RE: 2/15 TC Meeting, Item 6-B, Lincoln/Marshall/Pacific Corridor Project

Transportation Commission meeting
February 15, 2023

Ninth Street — *Included in 2030 Low Stress Backbone

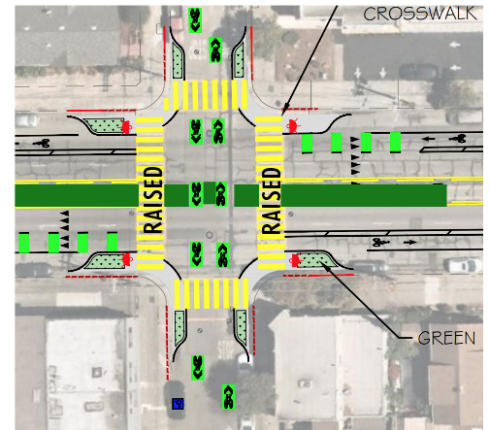
Raise the intersection, or both crosswalks across Lincoln; add pedestrian refuges and a modal filter to prohibit left turns (which will also help

reduce traffic volumes on the neighborhood greenway); make sure rapid flashing beacon activation buttons are easily accessible to people on bikes; install additional lighting.

St Charles — *Included in Low Stress Vision Network

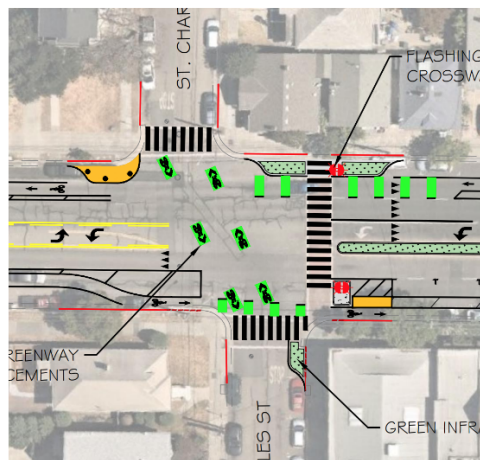
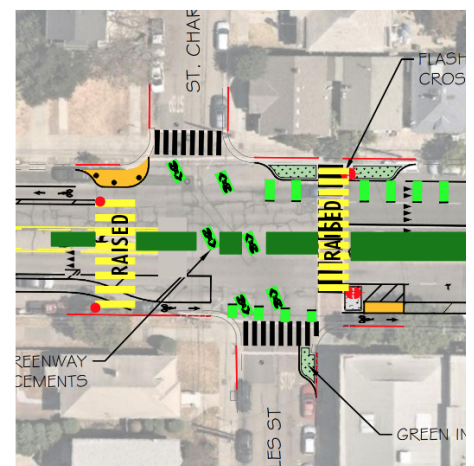
Add a high visibility crosswalk and rapid flashing beacon to the west side; raise intersection or both crosswalks; add pedestrian refuges and a modal filter (which will also help reduce traffic volumes on the neighborhood greenway); make sure rapid flashing beacon activation buttons are easily accessible to people on bikes; install additional lighting.

Lincoln crossing Broadway (a neighborhood greenway here) — *Included in 2030 Low Stress Backbone

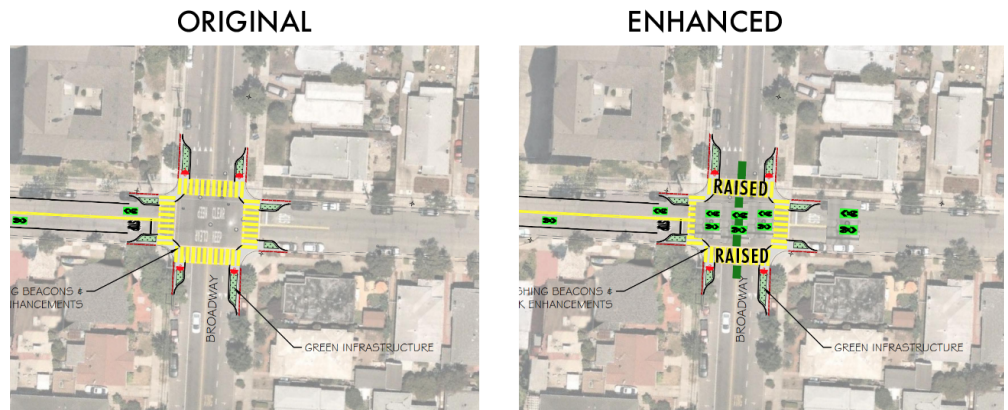
Raise the intersection or both crosswalks across Broadway; add pedestrian refuges and a modal filter; add bike stencils on Broadway; make sure rapid flashing beacon activation buttons are easily accessible to people on bikes; ensure sufficient lighting.
